SUBJECT: AMENDMENT TO THE TECHNICAL SPECIFICATIONS FOR SUSQUEHANNA STEAM  
ELECTRIC STATION, UNITS 1 AND 2 (TAC NOS. 91998 and 91999)

The amendments incorporate a change in the Station Technical Specifications (TSs) for both units that modifies the requirement in TS 4.4.4.3.a to have the pH of the reactor coolant measured every 72 hours. The amendments add the clarification that the pH measurement will be performed only when the coolant conductivity is greater than 1.0  $\mu\text{mho/cm}$  at 25°C (77°F).

SAFETY EVALUATION BY THE OFFICE OF NUCLEAR REACTOR REGULATION  
RELATED TO AMENDMENT NO. 156 TO FACILITY OPERATING LICENSE NO. NPF-14  
AMENDMENT NO. 127 TO FACILITY OPERATING LICENSE NO. NPF-22  
PENNSYLVANIA POWER & LIGHT COMPANY  
ALLEGHENY ELECTRIC COOPERATIVE, INC.  
SUSQUEHANNA STEAM ELECTRIC STATION, UNITS 1 AND 2  
DOCKET NOS. 50-387 AND 388

Figure  
 CONDUCTIVITY, pH, AND CHLORIDE  
 CONCENTRATION OF AQUEOUS SOLUTIONS  
 AT 77°F (25°C)

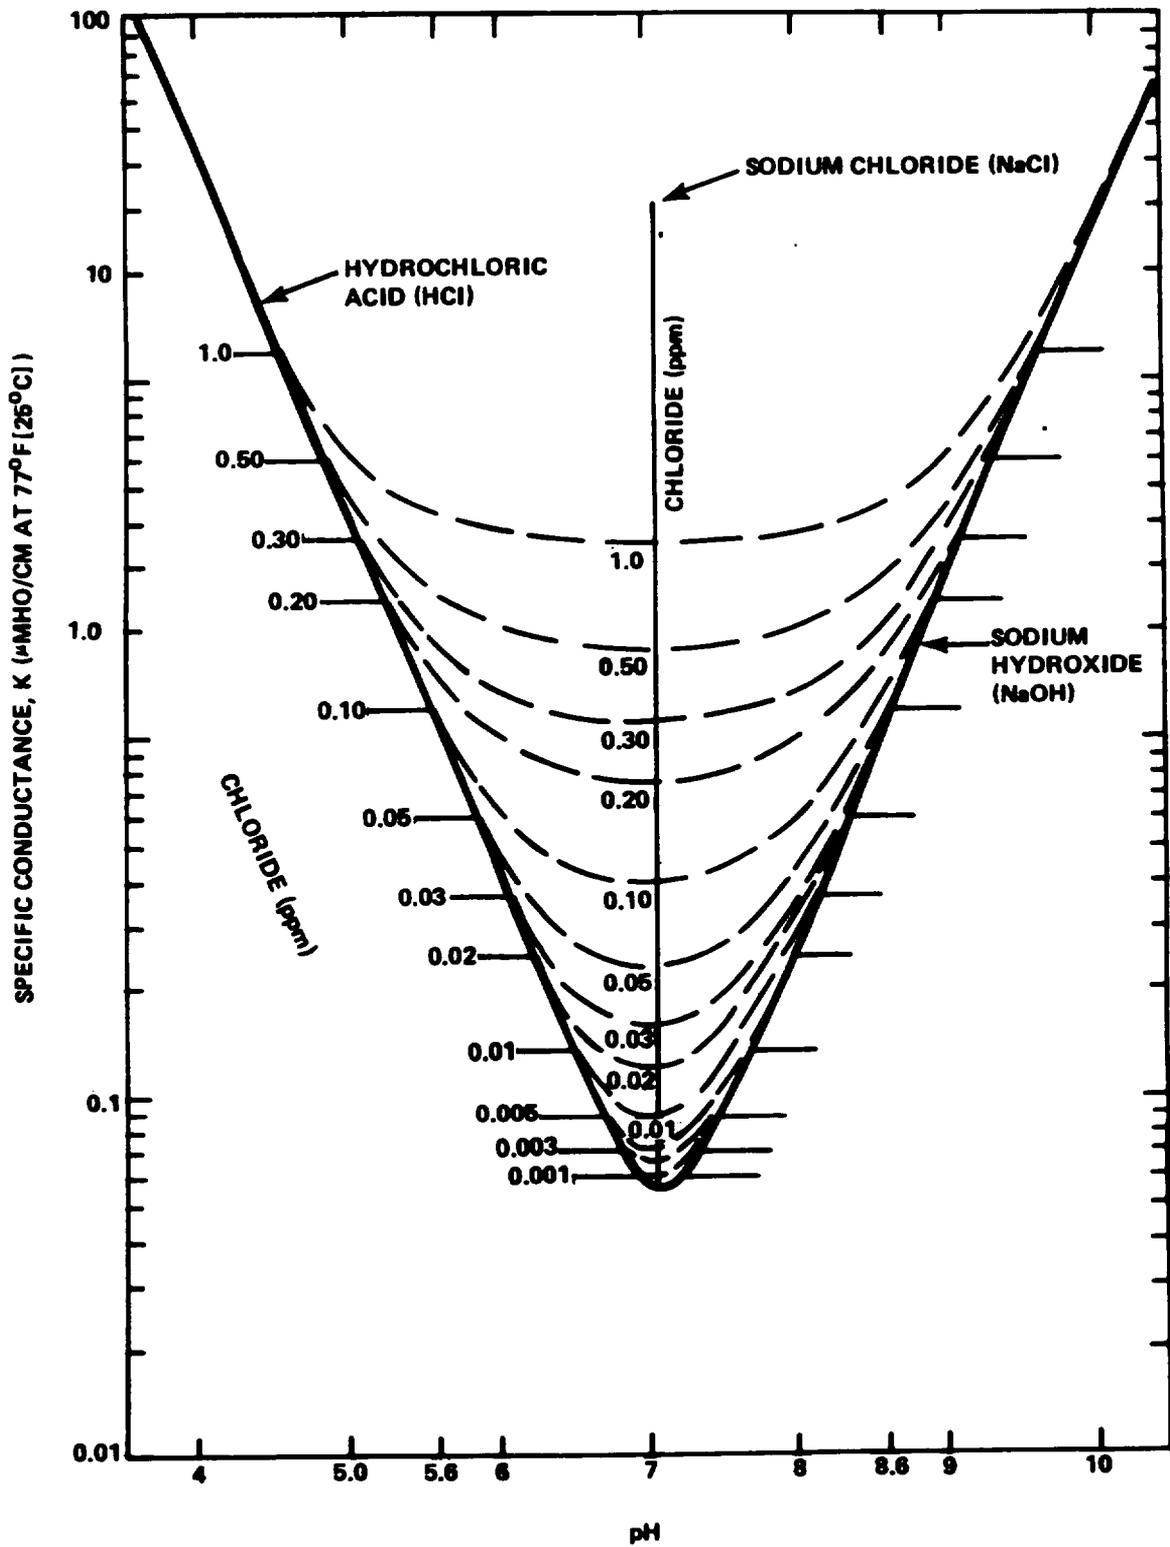
Figure 2 of RG 1.56 shows the conductivity and pH of simple aqueous solutions containing different amounts of hydrochloric acid (HCl) and sodium hydroxide (NaOH), which are commonly in the reactor coolant. This figure is attached to this safety evaluation report.

If a horizontal line is drawn on the attached figure for a measured specific conductance at 25°C (77°F), the line will cross the pH-conductance curve at two pH values. These two values are the maximum and minimum pH values for that conductivity and mark the ranges of possible pH values for that conductivity of the HCl/NaOH solution. The possible pH values will lie between the maximum and minimum pH values based on the different HCl/NaOH solutions that have the same measured specific conductance.

The licensee has proposed to use the attached figure to determine from the coolant conductivity if it is necessary to measure the pH of the sample. To do this, the measured conductivity must indicate the maximum range of pH for the sample (i.e., the actual pH can not be outside the range indicated by the conductivity and the attached figure). If the range of pH indicated by the conductivity is within acceptable values for the reactor coolant, then the pH does not have to be separately measured. Therefore, the conductivity would have indicated that all the possible pH values for the coolant are within acceptable values and the pH of the coolant does not have to be separately measured.

The error in using the V-shaped curve in the attached HCl/NaOH figure for the maximum range of pH values in the coolant is from the following: (1) the equivalent conductance for the chlorine and sodium ions are not the lowest values for possible ionic species in the coolant and (2) the error in the conductivity measurement for the coolant sample is not being taken into consideration. The error in equivalent conductance values is less than 80/350 (equivalent conductance of chlorine ions to hydrogen ions) for acidic solutions (pH about 5.6) and less than 50/200 (equivalent conductance of sodium ions to hydroxyl ions) for basic solutions (pH about 8.6). The 80 and 50 are the equivalent conductance values for chlorine and sodium ions, respectively. This is an error of about 25 percent. The error in the conductivity measurement is about 5 percent. The total error would be about 30 percent.

An error of 30 percent in hydrogen ion concentration is about an error of 0.11 units in the pH. This is about the error in the measurement of pH. The attached curve is not sufficiently detailed to show differences as small as 0.1 pH units. Therefore, the error in using the V-shaped curve in the attached figure to determine the maximum range of pH values in the coolant is not significant.

The licensee has proposed to use a conductivity value of  $1.0 \mu\text{mho/cm}$  at  $25^\circ\text{C}$  ( $77^\circ\text{F}$ ) as the limit at or below which the pH measurement of the reactor coolant does not have to be performed. From the attached figure, the range of pH values of the coolant would be between 5.6 and 8.6 (i.e.,  $5.6 < \text{pH} < 8.6$ ). This range of pH values for the reactor coolant is in accordance with the table of allowable values in RG 1.56 and the pH measurement of the coolant would not be necessary. As discussed above, the error in the pH values at this limit will be about 0.1 units and this error is sufficiently small to not be significant.

Therefore, the conductivity limit of  $1.0 \mu\text{mho/cm}$  at  $25^\circ\text{C}$  ( $77^\circ\text{F}$ ) proposed by the licensee is acceptable to determine if pH measurements of the reactor

Based on its evaluation, the staff concludes that the proposed qualification on the surveillance requirement in TS 4.4.4.b.3.a, to limit pH measurements of the reactor coolant to when the measured conductivity values of the coolant are greater than 1.0  $\mu\text{mho/cm}$  at 25°C (77°F), is acceptable.
